Notice of Defect

This notice is sent to you in accordance with the requirements of the Motor Vehicle Safety Act. This is to inform you that your vehicle may contain a defect that could affect the safety of a person. The VIN numbers of your affected Polar trailers are listed above. We are referring to this action as the "Dexter Recall" and it has been assigned file number 2021-320 by the Department of Transport.

Subject: SMART-STEER 2.0 Bolt-On Steer Arm Reinforcement Welds

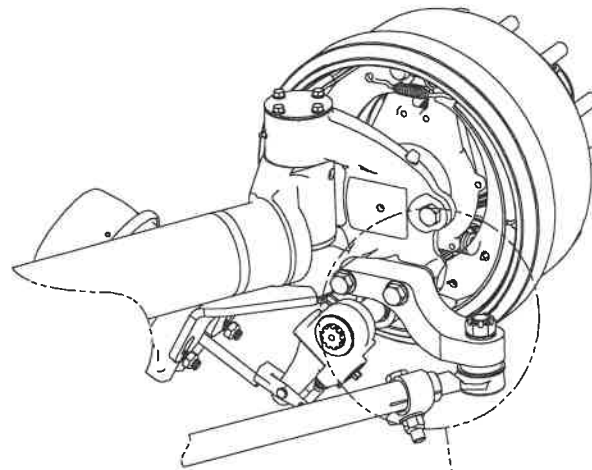
Based on feedback from our customers, Dexter Heavy Duty has become aware that under certain loading conditions, the 8-7/8" steer arm setup on the SMART-STEER 2.0 axle is prone to shearing the attaching steer arm bolts. This will lead to a failure in the steer arm assembly.

Dexter recommends that you perform a steer arm inspection of your axle(s) as soon as possible; but no later than four weeks after receiving this service bulletin. Please follow the steps listed below:

1. Visually inspect steer arm bolts and washers for mechanical tightness and replace if necessary.
2. Ensure the steer arm bolts are torqued to 400 Ft. Lbs.
3. Place welds as shown on page three of this bulletin. If you would like a copy of engineering drawing 750049, please contact one of the service technicians listed below.

DETAIL A
SCALE 1 : 4

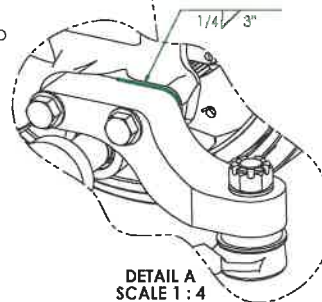
NOTE:
TURN KNUCKLE AT FULL TURN TO
GAIN ACCESS TO STEER ARM
AND WELD

DETAIL C
SCALE 1 : 4

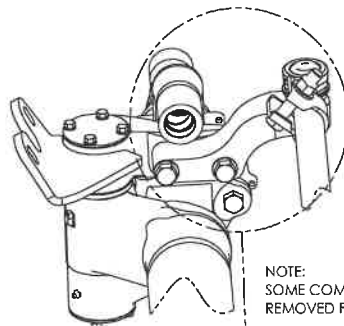
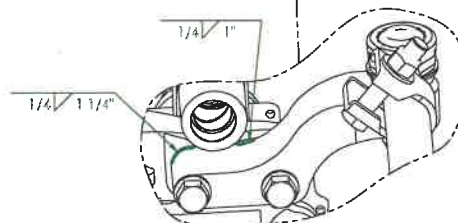
NOTE:
SOME COMPONENTS WERE
REMOVED FOR CLARITY.

DETAIL B
SCALE 1 : 4

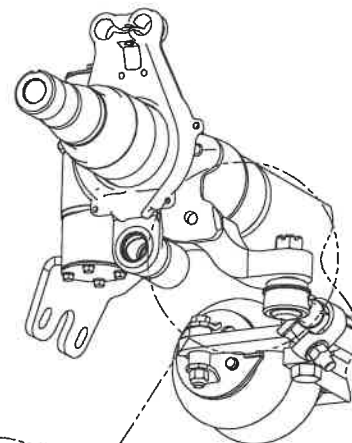
NOTE:
SOME COMPONENTS WERE
REMOVED FOR CLARITY.
